**PUBLIC INTEREST REVIEW FOR GROUNDWATER APPLICATIONS**

TO: Water Rights Section Date 25 June 2010  
 FROM: Groundwater/Hydrology Section Gerald H. Grondin  
Reviewer's Name  
 SUBJECT: Application G-17307 Supersedes review of N.A.  
Date of Review(s)

**A. GENERAL INFORMATION:** Applicant's Name: George Jaska County: Lake

A1. Applicant(s) seek(s) 0.78 (350 gpm) cfs from 1 well(s) in the Goose and Summer Lakes Basin,  
Thomas Creek watershed in Goose Lake sub basin Quad Map: Lakeview NW

Transient Stream Depletion (Jenkins, 1970; Hunt, 1999)  
Proposed Well to Thomas Creek

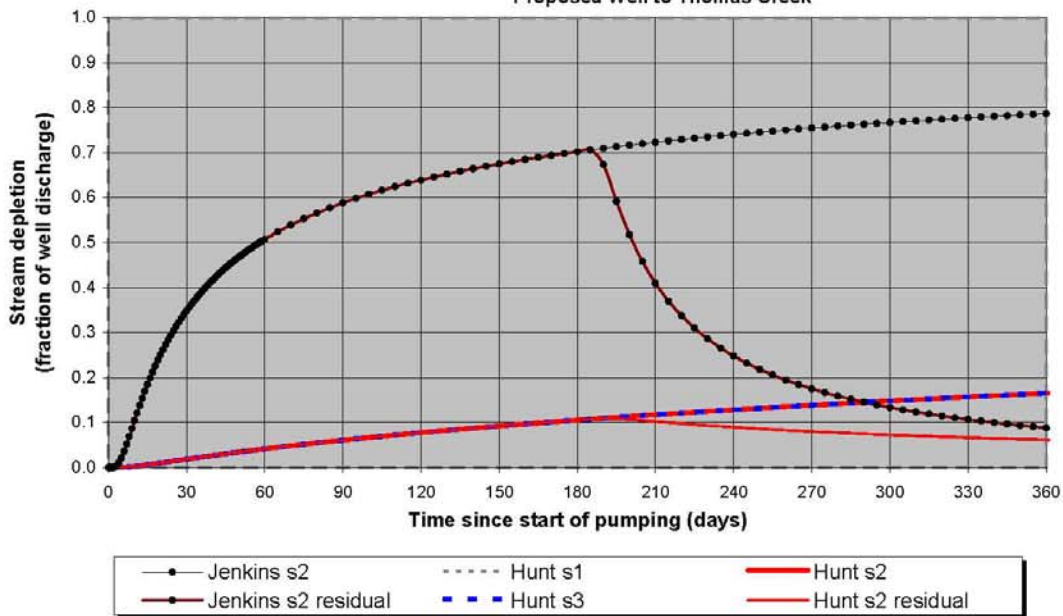
**The proposed well is more than 1.0 mile from Thomas Creek.**

**Hunt (1999) was used to calculate the interference with Thomas Creek. The parameters used were a horizontal hydraulic conductivity of 1.6 feet/day (transmissivity = 800 ft<sup>2</sup>/day based on specific capacity data for LAKE 2146, LAKE 2150 and LAKE 2153), an intermediate value of 0.001 for the storage coefficient, stream width of 15 feet average, a streambed conductivity of 0.016 feet/day (aquifer horizontal conductivity/100), and a streambed thickness of 10 feet. These parameters are within the ranges found in Morgan (1988) and somewhat less than the range found in Gonthier (1985). A pro-rated pumping rate of 0.2186 cfs (98.13 gpm) was used. It was derived from the total annual volume (26 million gallons) divided by total annual minutes.**
